## V2500-A1 SERIES PROPULSION SYSTEMS SERVICE BULLETIN

This document transmits the Revision 1 of Service Bulletin V2500-ENG-72-0548 and the Revision 1 of the Supplement

# V2500-ENG-72-0548

ENGINE – PROVIDE NEW SECOND STAGE TURBINE AIR SEAL1. Planning InformationA. Effectivity

LOCATION OF THE STAGE 2 HIGH PRESSURE TURBINE AIR SEALS  
FIGURE 1

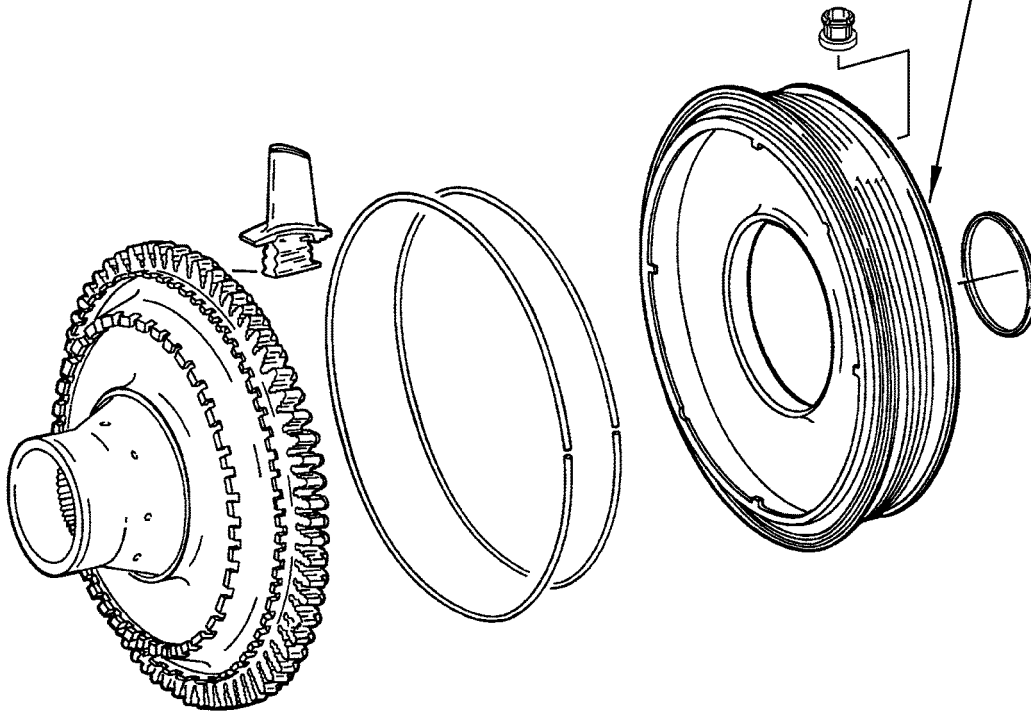
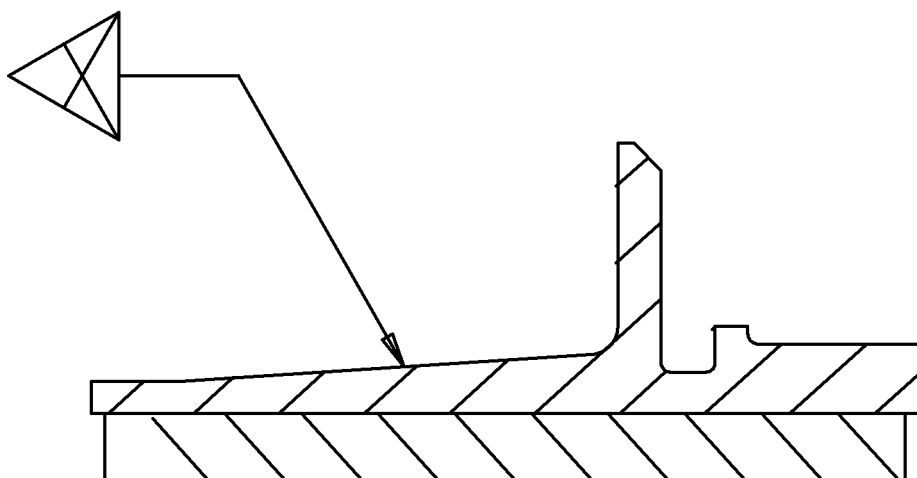
- (1) Provide new Second Stage Turbine Air Seal. See Figure 1.

- (4) Disassemble per Reference (23) Engine Manual, Chapter/Section 72-45-00-030-001.
- (5) Discard Seal-Air Turbine Assy, 2 Stage PN 2A1160 or PN 2A3108 or PN 2A0487 or PN 2A3185 and replace with PN 2A4196.

INSTALL THE 2A4196  
STAGE 2 HIGH PRESSURE  
TURBINE AIR SEAL (1OFF)

RE-IDENT RING ASSEMBLY  
FIGURE 2

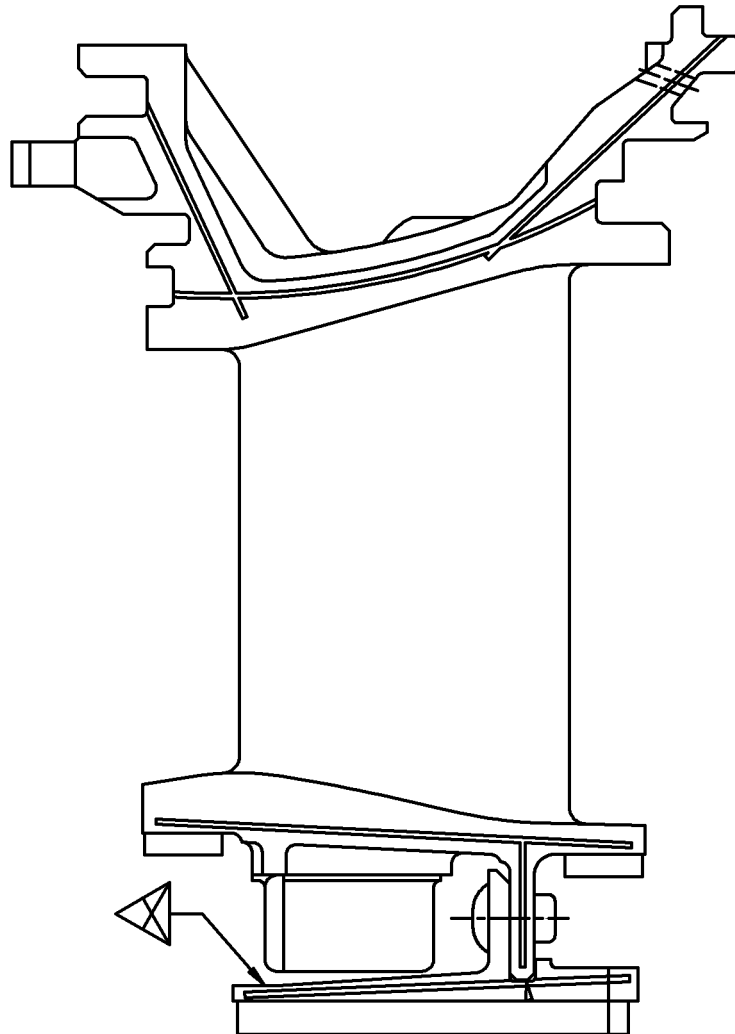
- (iii) Mark the ring segment re-identification part number using the vibration peen method specified per Reference (24), Standard Practices Manual, Chapter/Section 70-09-00, marking of parts. See Figure 1 for the area to mark the part. The re-identification part number is as follows (per Table 1).

OLD PART NO.	NEW PART NO.
2A3431-01	2A1106-01

RE-IDENT VANE CLUSTER  
FIGURE 3

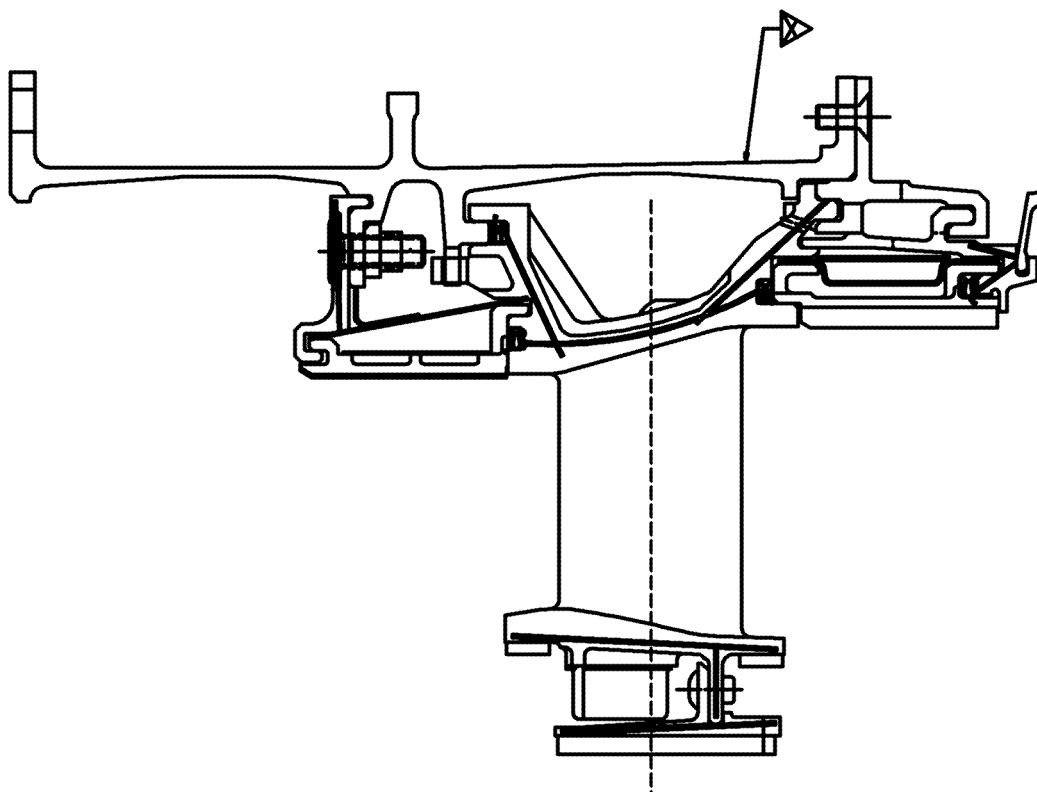
(i) Mark the ring segment and vane cluster re-identification part number using the vibration peen method specified in Reference (24), Standard Practices Manual, Chapter/Section 70-09-00, marking of parts. See Figure 2 for the area to mark the part. The re-identification part number is as follows (Table 2 and 3):

OLD PART NO.	NEW PART NO.
2A5002	2A3272
2A3272-001	2A3272

OLD PART NO.	NEW PART NO.
2A4902	2A3172
2A3172-001	2A3172

RE-IDENT CASE AND VANE ASSEMBLY  
FIGURE 4

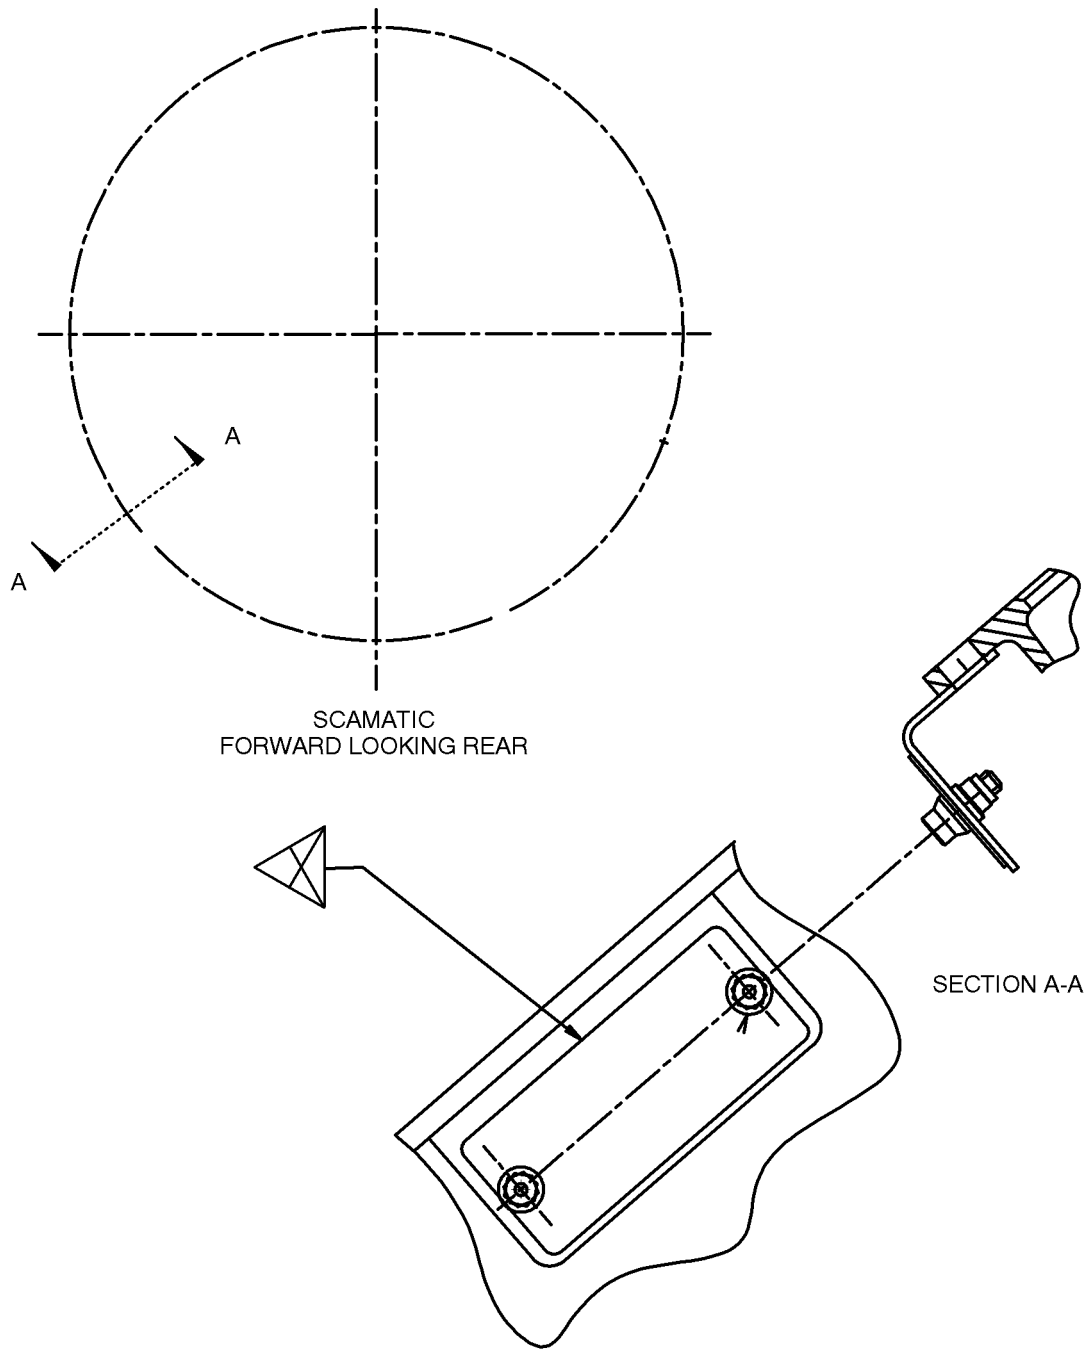
(b) Mark the case and vane assy re-identification part number using the vibration peen method specified in Reference (24), Standard Practices Manual, Chapter/Section, 70-09-00, marking of parts. See Figure 3 for the area to mark the part. The re-identification part number is as follows (Table 4):

OLD PART NO.	NEW PART NO.	REMARKS
2A3415	2A3415-001	
2A3304-002	2A3304-002	Verify Part Marking Non-Trench Ring Seg (2A1106) Config
2A3304-003	2A3304-003	Verify Part Marking Non-Trench Ring Seg (2A1106) Config
2A3468	2A3468-002	
2A3468-001	2A3468-003	
2A4099	2A4099-001	
2A4099	2A4203	
2A3304	2A3304	Verify Part Marking Non-Trench Ring Seg (2A1106) Config
